Utility: ComEd Investigators: John Stutsman (Staff)

Feeder Ckt: S431 City: Odell Voltage: 4/12kV Date: Monday, September 21, 2009

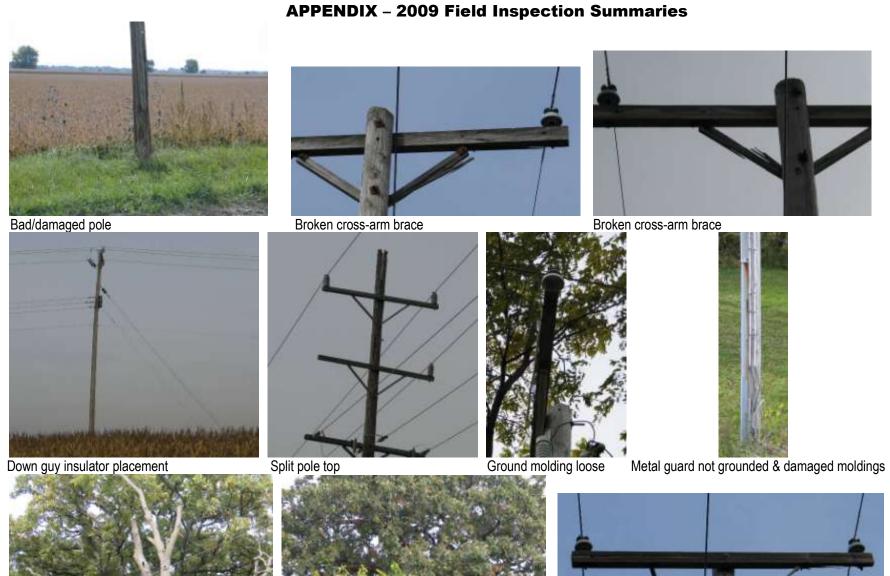
Loose hardware & bad pole top
